Early Site Permit (ESP) Application for the Clinton ESP Site
Docket No. 52-007

Subject: Responses to Supplemental Draft Safety Evaluation Report (DSER) Items

Re: Letter, U.S. Nuclear Regulatory Commission (W. D. Beckner) to Exelon
Generation Company, LLC, (M. Kray), dated August 26, 2005,
Supplemental Draft Safety Evaluation Report for the Exelon Early Site
Permit Application

This letter provides response(s) to the following draft safety evaluation report (DSER) Supplement Open Items.

Figure 2.5.1-1-1: Comparison of mean repeat time distributions computed assuming a Poisson model for prehistoric earthquake dates developed from data in the three sections of the New Madrid seismic zone

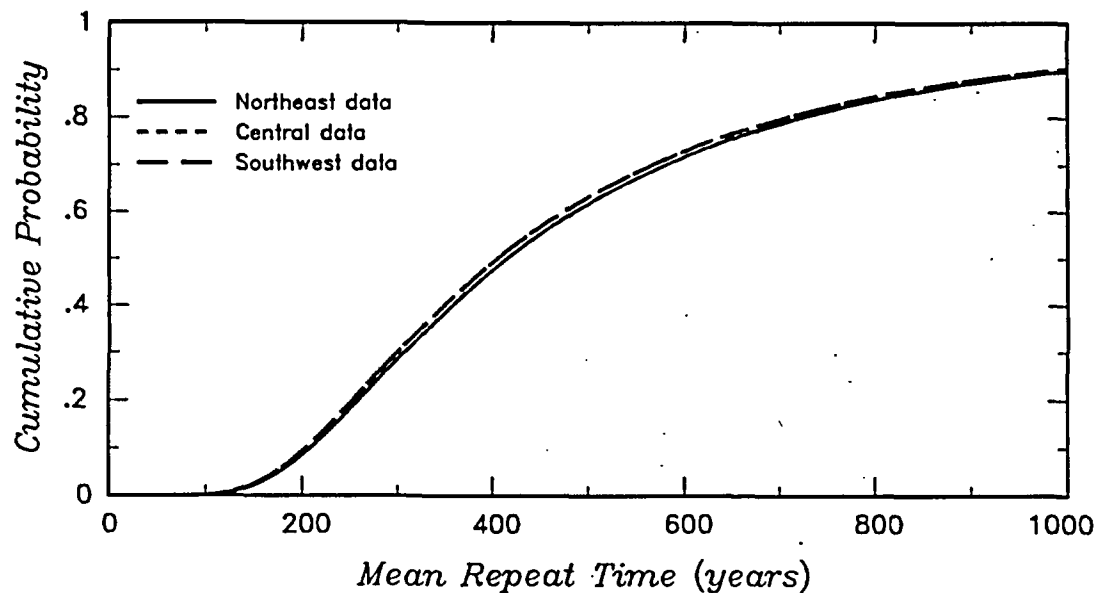
The calculation of the occurrence times presented in the response to RAI 2.5.2-5 were based on the estimated dates for previous New Madrid earthquakes derived from radio-carbon dating of paleoliquifaction features in the north-east portion of the New Madrid seismic zone in the vicinity of the New Madrid North fault (Attachment 2 to Appendix B of the FSAR). These analyses were repeated using data from the central and southwestern portions of the New Madrid seismic zone. All three sets of data produce essentially the same estimates of mean return period. Figure 2.5.1-1-1 shows the uncertainty distributions for mean repeat time derived from the three data sets assuming a Poisson recurrence model. The updated occurrence rates of equivalent annual frequency of New Madrid earthquake sequences were computed by combining the estimated dates for prehistoric earthquakes from all three sections of the seismic zone. Figure 2.5.1-1-2 shows the resulting distributions for mean repeat time derived using the Poisson and BPT models. Table 2.5.1-1-2 lists the resulting distributions for equivalent annual frequency of New Madrid clusters.

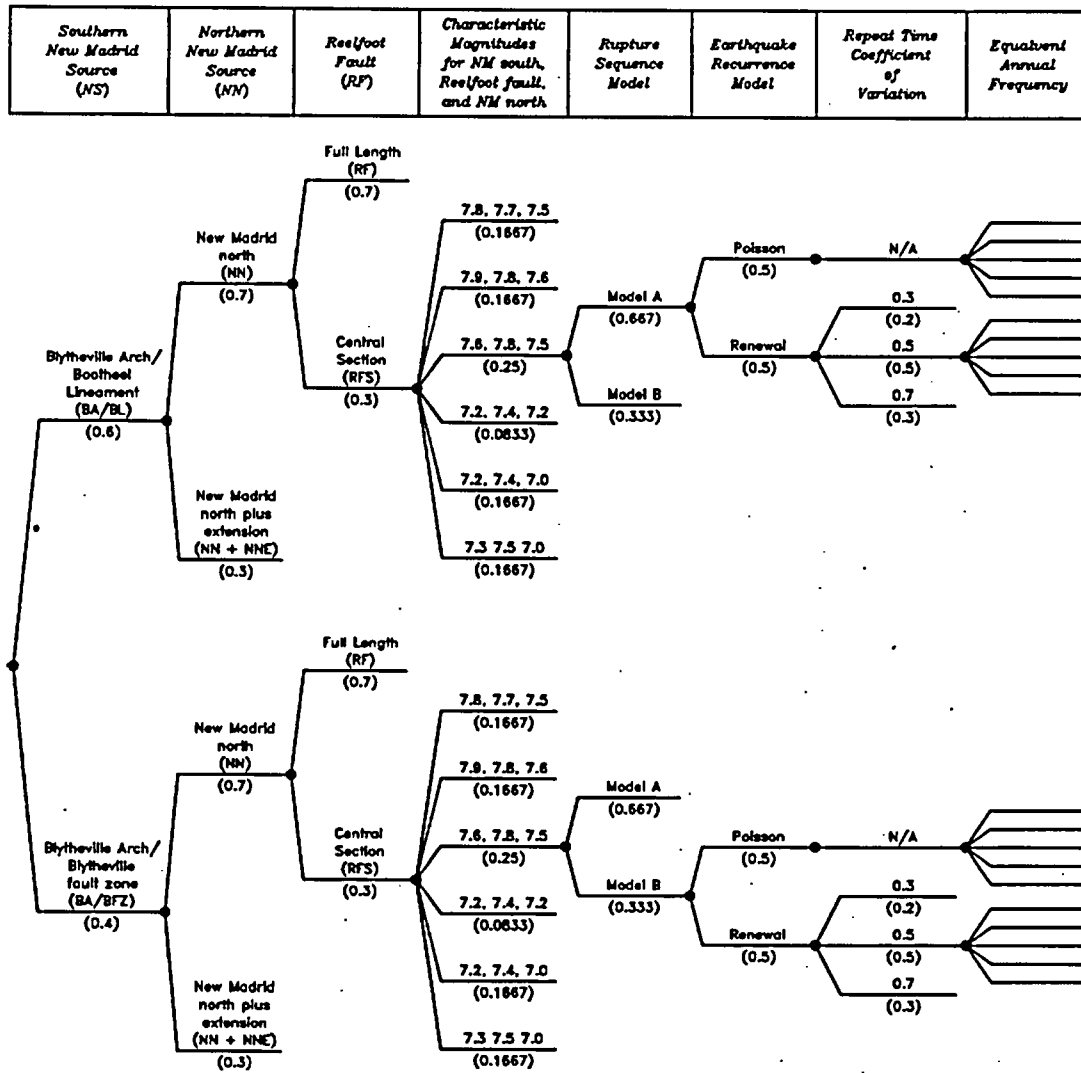
The revised logic tree for the New Madrid repeating earthquake source is shown on Figure 2.5.1-1-3. The Poisson and renewal recurrence models are given equal weight. The renewal model is considered more appropriate on a physical basis for the behavior of characteristic earthquakes on active faults. The Working Group (2003) applied weights of 0.7 and 0.6 to non-Poissonian behavior for the San Andreas and Hayward faults, respectively. For other, less active sources, they assigned a weight of 0.5 or less

- 3) Revision of SSAR, Appendix B, Section 4.1, Figures 4.1-1, 4.1-3, 4.1-9 thru 4.1-16, 4.1-19 thru 4.1-21. For example, SSAR Appendix B, Figure 4.1-1 will be updated with the information in the open item response Figure 2.5.1-1-3, and SSAR Appendix B, Figure 4.1-3 will be updated with the information in the open item response Table 2.5.1-1-2, and Figures 2.5.1-1-1 and 2.5.1-1-2.

Figure 2.5.2-1-1: Fit of Equation (1) to Atkinson and Boore (1995) simulated ground motion data for hard rock conditions

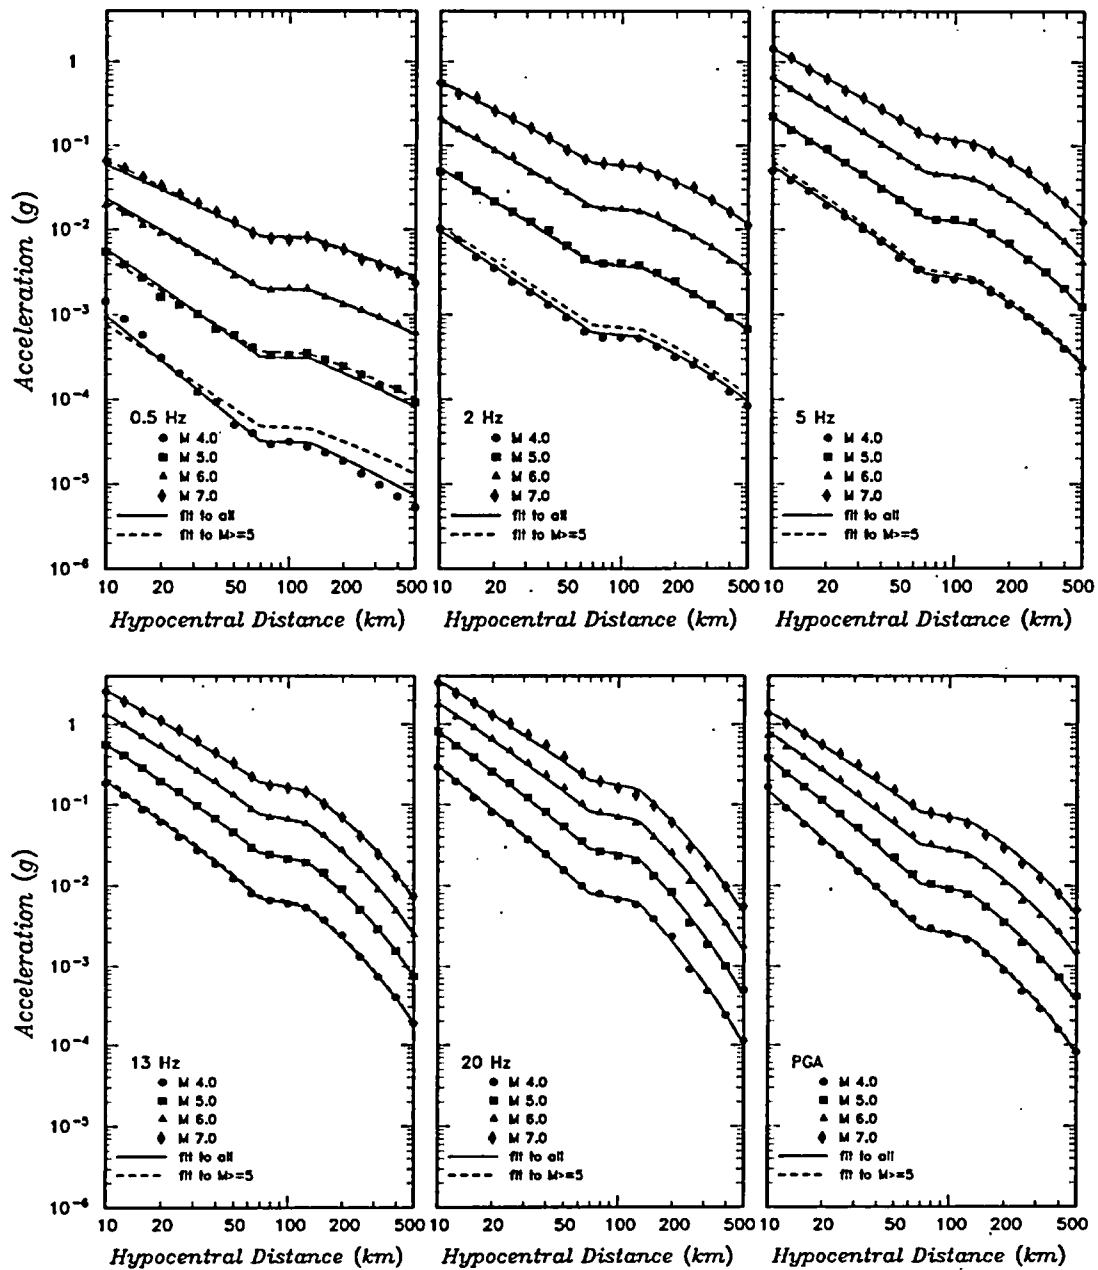
The Atkinson and Boore (1995) and Frankel et al. (1996) ground motion models are defined in terms of tables of median ground motion values for a range of magnitudes and hypocentral distances. EPRI (2004) developed functional forms to represent these models in their analysis. The first step was to fit a functional form to the tabular data. Figures 2.5.2-1-1 and 2.5.2-1-2 show the tabulated data and the resulting fits using the functional form

for Atkinson and Boore (1995) data (Figure 2.5.2-1-1) and

Figure 2.5.2-1-2: Fit of Equation (2) to Frankel et al. (1996) simulated ground motion data for hard rock conditions

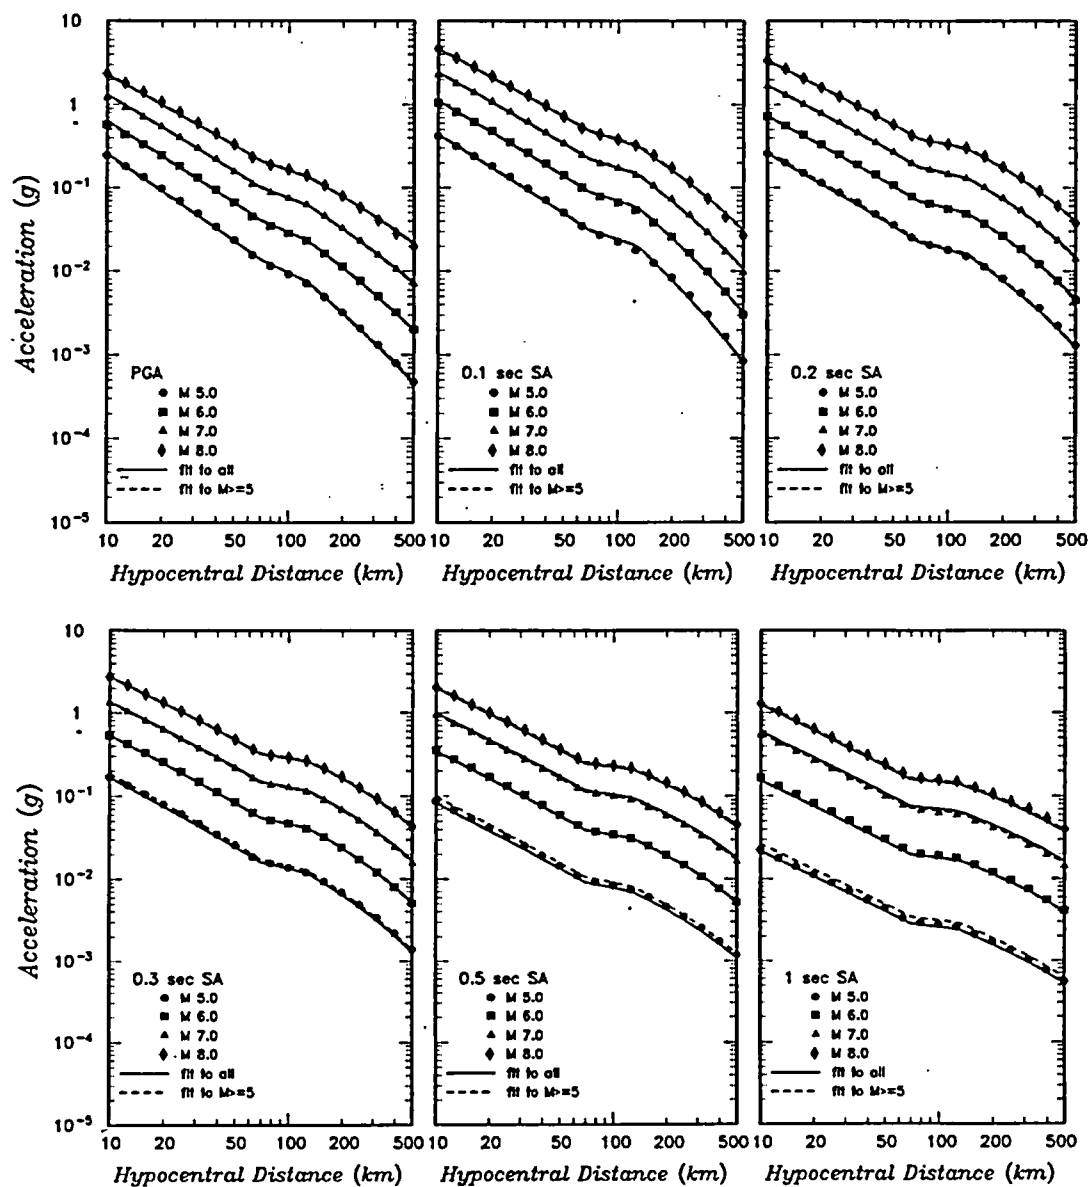
for Frankel et al. (1996) data (Figure 2.5.2-1-2) where m is moment magnitude and r is equivalent point-source distance. These forms were chosen to match the characteristics of the ground motion simulation models used in developing the tabular data, in particular the form of distance attenuation. For ease in comparing these two relationships with the other models within their respective clusters, the "hypocentral" distance versions were converted into r_{JB} version by the following process. A synthetic data set was created by simulating data for a specific set of r_{JB} values using a distribution of equivalent point source depths. The point source depth distributions developed by Silva et al. (2002) were used in generating the synthetic data. These point source depth distributions were developed from the hypocentral depth distributions published by EPRI (1993) accounting for adjustments from hypocentral to asperity depth as a function of earthquake magnitude. Table 2.5.2-1-1 gives the parameters of these distributions. For comparison, EPRI-SOG (1988) used a fixed depth of 10 km in applying the stochastic point source ground motion models and Frankel et al (1996) used a fixed depth of 5 km with a minimum hypocentral depth of 10 km. Figure 2.5.2-1-3 shows examples of the simulated data for the Frankel et al. (1996) ground motion model. The simulated data were then fit by modified versions of Equations (1) and (2) to add a "fictitious depth" term to convert r_{JB} into equivalent point source distance. The modified functional forms are:

Figure 2.5.2-1-4: Comparison of EPRI (2004), USGS (Frankel et al., 2002), and hypothetical EPRI-SOG (1988) implementation of the Frankel et al. (1996) ground motion model in terms of r_{JB}

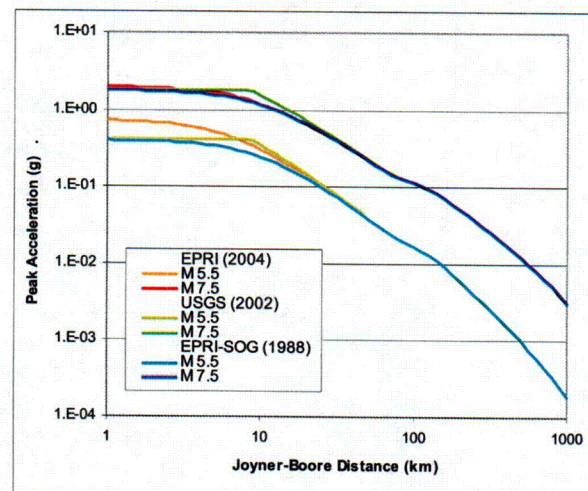
Figure 2.5.2-1-4 compares median ground motion estimates for the EPRI (2004) and the Frankel et al. (2002) implementation of the Frankel et al. (1996) ground motion model in terms of r_{JB} . The EPRI (2004) implementation provides a smooth variation with distance and results in somewhat higher median ground motions at very small values of r_{JB} . Also shown on Figure 2.5.2-1-4 are the median ground motion estimates for the Frankel et al. (1996) ground motion model using the EPRI-SOG (1988) implementation of a fixed depth of 10 km.

Figure 2.5.2-1-5: Rupture area scaling relationships for eastern North America (ENAM) and western North America (WNAM) from Somerville et al. (2001)

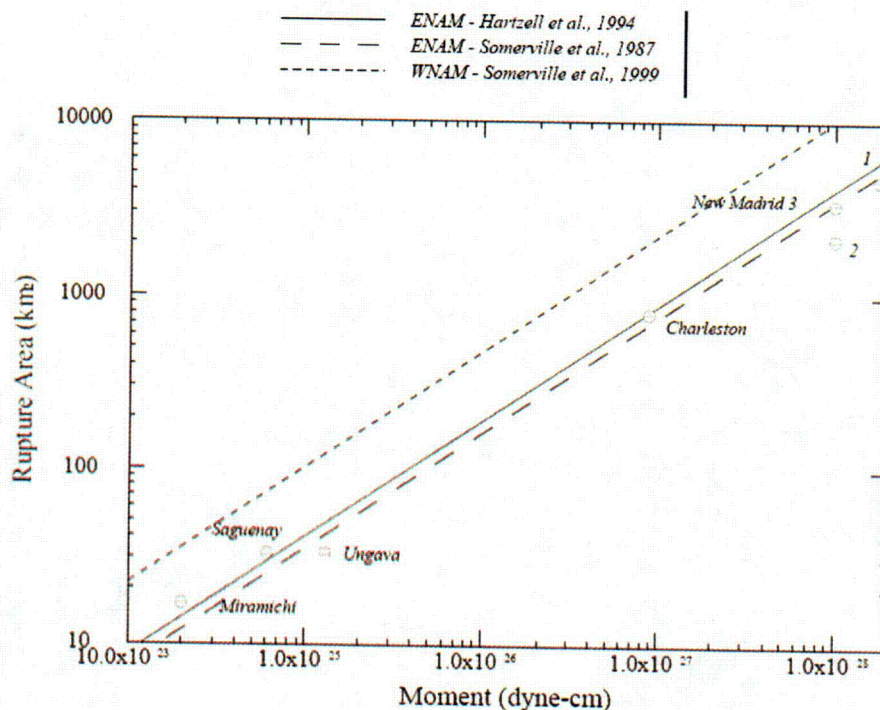
For a given moment magnitude and epicentral distance, a set of possible rupture orientations was simulated. The rupture size was obtained using the relationship for CEUS earthquakes proposed by Somerville et al. (2001) for eastern North America (Figure 2.5.2-1-5):

Figure 2.5.2-1-7: Plot of equivalent Joyner-Boore distance versus epicentral distance for the Cluster 2 median model

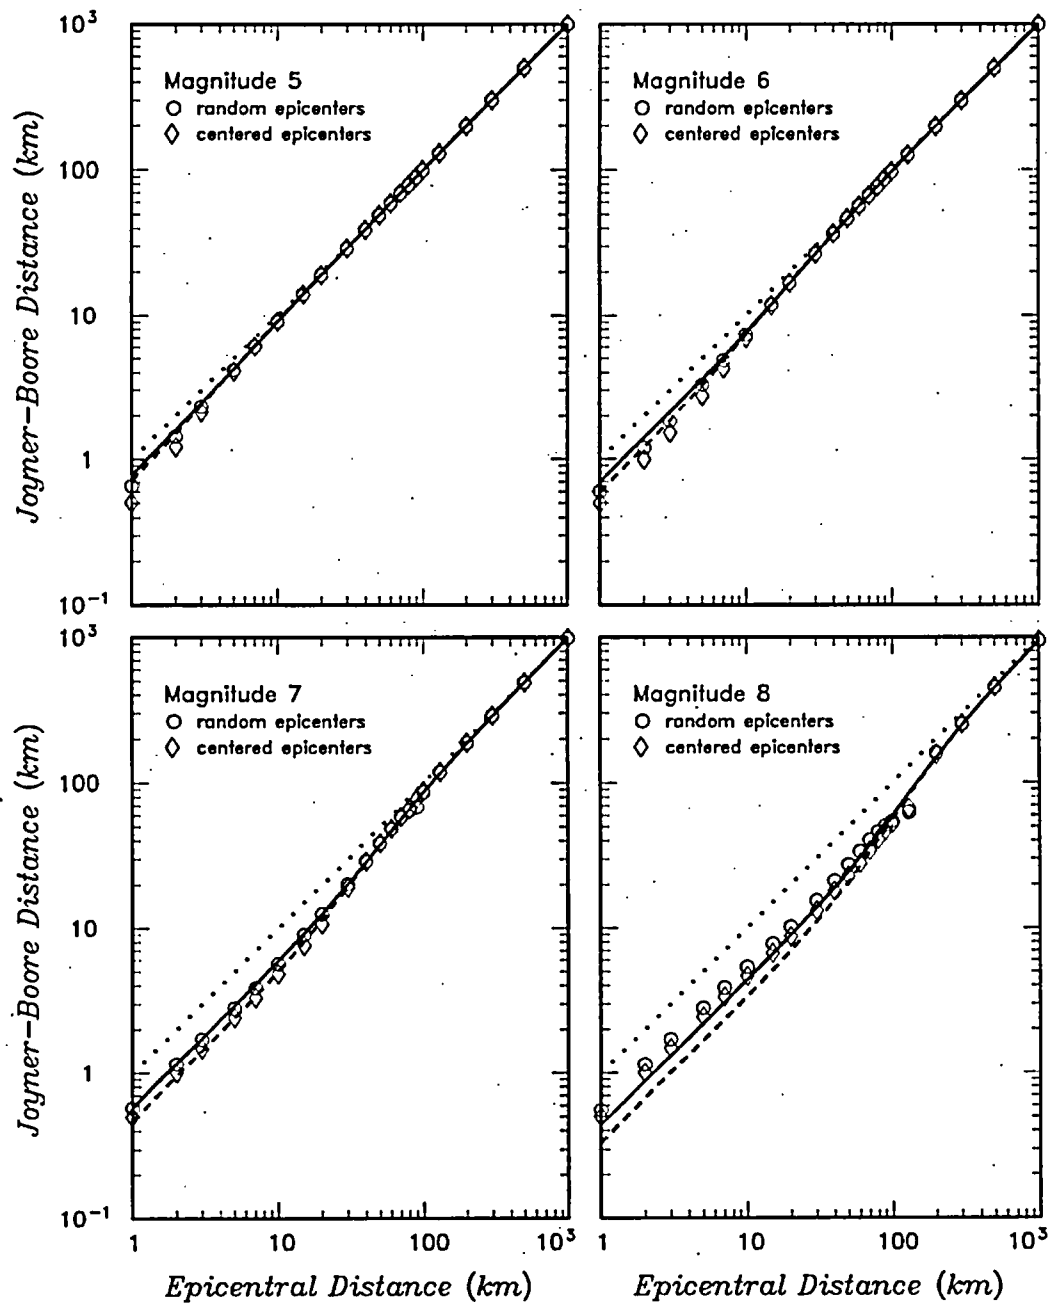
the median ground motion model for Cluster 2, produces the same level of ground motion as the geometric mean of all of the ground motions for the simulated ruptures at the j^{th} epicentral distance. Figure 2.5.2-1-7 shows plots of the equivalent Joyner-Boore distance versus epicentral distance for the Cluster 2 median model. An algebraic relationship was then fit to the simulated data to provide a readily usable relationship for PSHA applications. These relationships are of the form
